# SEA DIKES NORTHERN PART OF VIET NAM (Red River Delta)

- Review -

Authors: K.W.Pilarczyk P.J.Eversdijk G.Kant

May 1996

Figure 4.1 Different types of grouting

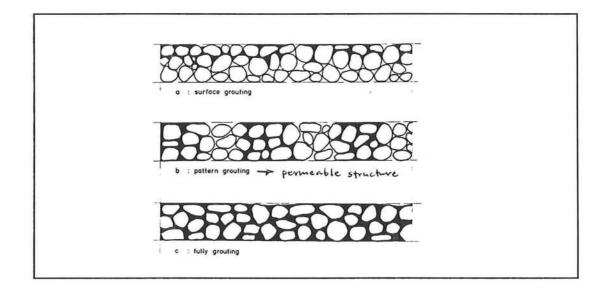
In case of fully grouting of (unstable) riprap the permeability will be drastically reduced, and also the surface roughness will be reduced, providing as a result of nearly no reduction of runup. In such case the pattern grouting (local grouting) with strips of concrete may somewhat help to increase the permeability, and thus, the reduction of runup (see figure 4.1).

Figure 6.1 Design Cross-sections in Quang Ninh Province

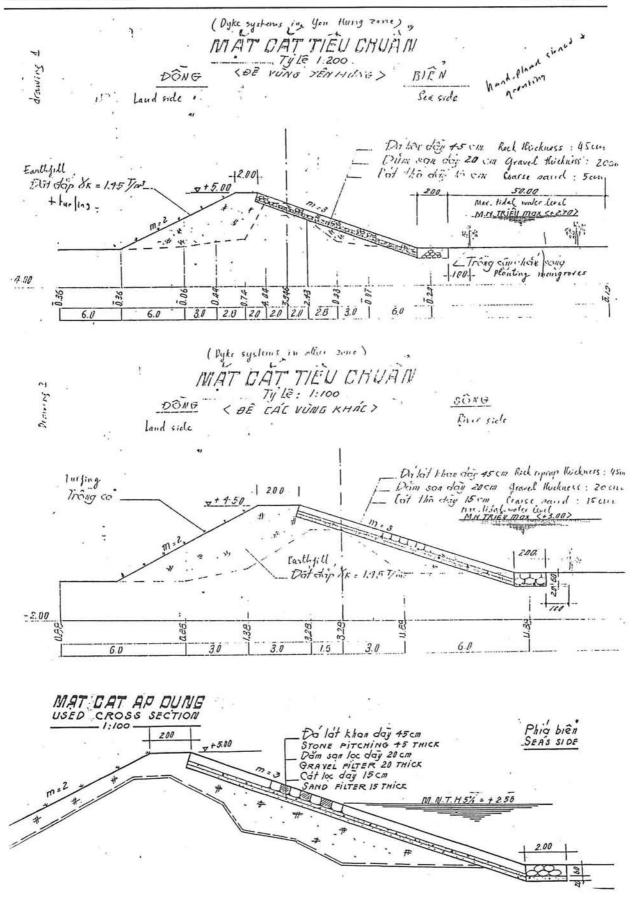
- What does it mean in report [1], "reduction of stone size by 25%", when calculating stone size?

Figure 7.1 Typical cross-section of sea-dike no. I - Hai-Phong Province

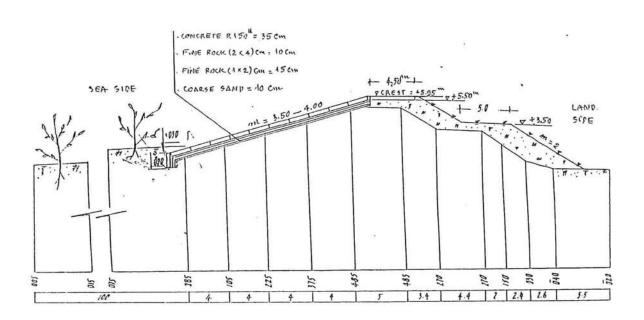
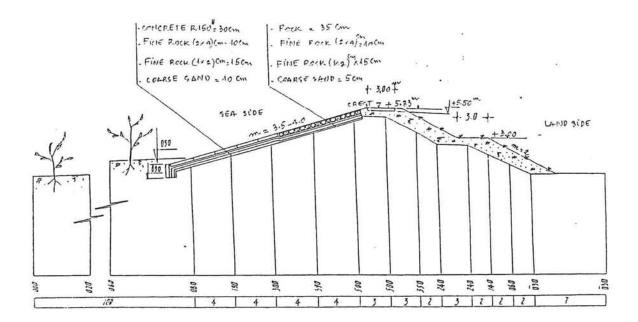
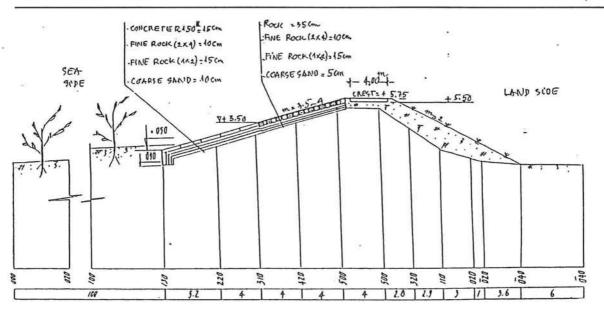
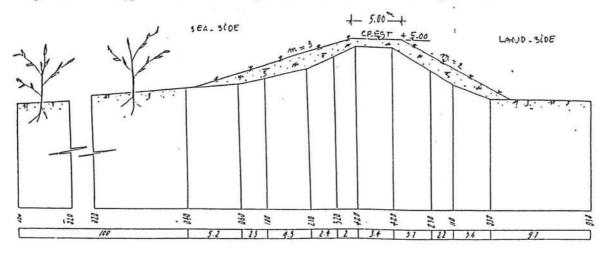
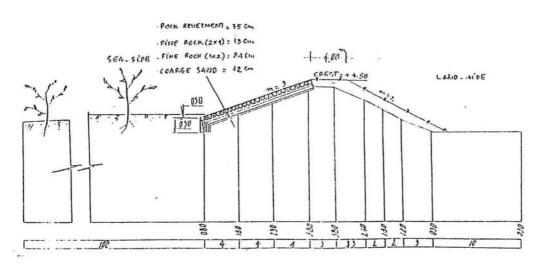
- Prediction of hydraulic boundary conditions (tidal level, storm surge, wave height, etc.) is not clear. The calculated wave heights and wave length are probably not correct and should be examined once again (including influence of various foreshore types).

- The design drawings, especially concerning toe protection, need further improvement. The present toe construction seems to be insufficient.
- Proper specifications for execution should be prepared.

- Extra attention should be given to the execution of the transition between the two revetment types.

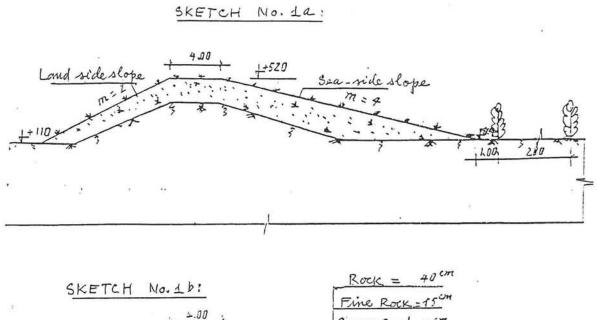
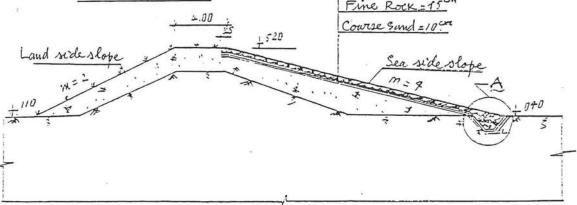
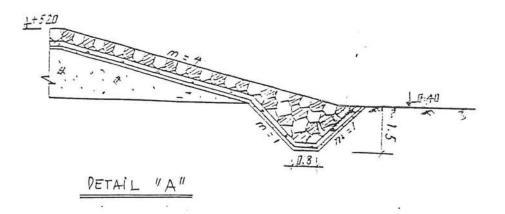
- The connection between the revetment and the layer of clay on the crest is insufficient; due to rainfall and overtopping water clay will erode to filter construction under pitched stone revetment).

- Construction of toe protection in lit 1 only vaguely conveyed. The construction appears to be insufficient.
- A sufficient layer of clay with a vegetation of grass is important to prevent damage due to overtopping.

- Above the calculated crest height an extra size is needed due to settlement of the subsoil which will occur due to load of earthfill.
- Because uncertainties concerning calculation of the wave height, the calculated stone size is also uncertain.

- In the report [3] riprap is calculated while on the drawings a pitched stone is shown! It must be clear what is applied: riprap or pitched stones. These are two different revetments which should be calculated by separate methods.

- How is it possible that you get such low wave height of about 1.5 m for wind of 24 m/s and fetch length of 300 km? It is only possible when the depth of the sea bottom is about 5 m, which we don't think it is!

Figure 9.1 Standard cross-section of sea dike in Nam Ha Province

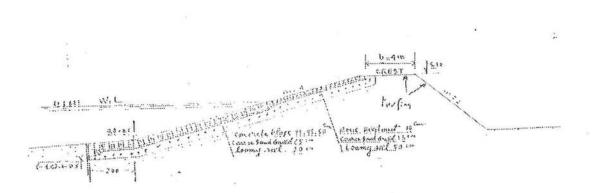
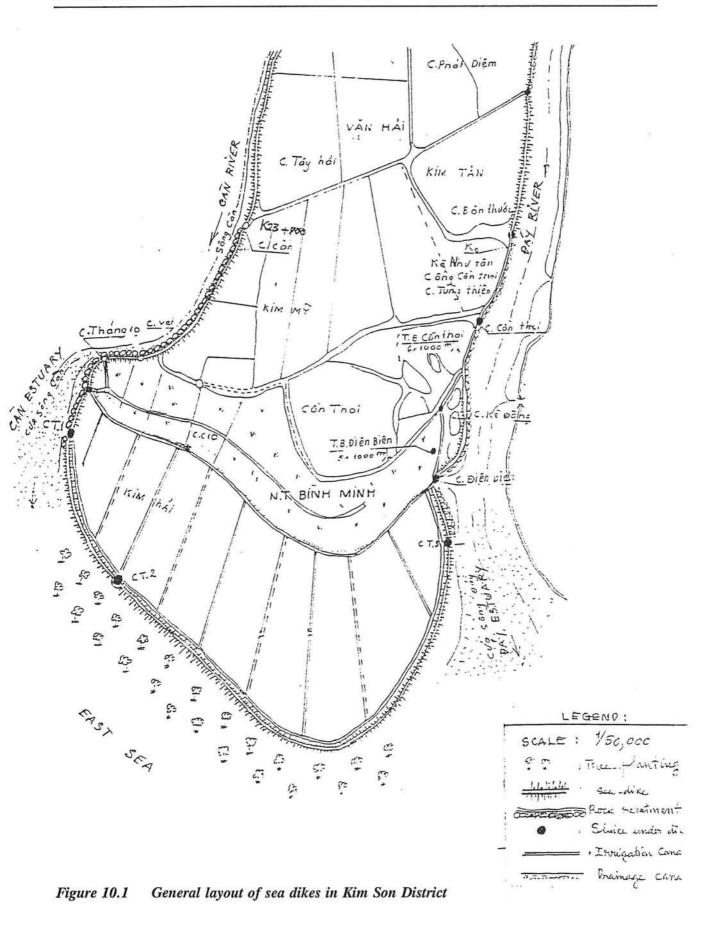
- The connection between the revetment and the layer of clay on the crest is insufficient; due to rainfall and overtopping water clay will erode to filter construction under pitched stone revetment).
- Construction of toe protection in lit 1 only vaguely conveyed. The construction seems to be insufficient.
- A sufficient layer of clay with a vegetation of grass is important to prevent damage due to overtopping.
- Above the calculated crest height an extra size is needed due to settlement of the subsoil which will occur due to load of earthfill.
- The prediction of the wave height should be examined once again taking into account the bathymetry of the foreshore.

For estuary dikes the wave height will probably about 1 m. Therefore, the actually calculated weight of stone is too big. Probably a riprap with stone size of about 30 cm will be sufficient.

- The crest height of the estuary dike is reduced by 0.5 m, "based on experience". Probably when the calculations are done properly one gets a lower crest height for estuary dikes in comparison with the crest height of the sea dikes, without introducing this kind of reduction.

- The remark given in the report [5] that "in case of using geotextile, we can replace conventional filter layer by geotextile", is only true for waves lower than 1, thus for estuary dikes. For high waves often an additional granular layer is needed between the toplayer and geotextile,
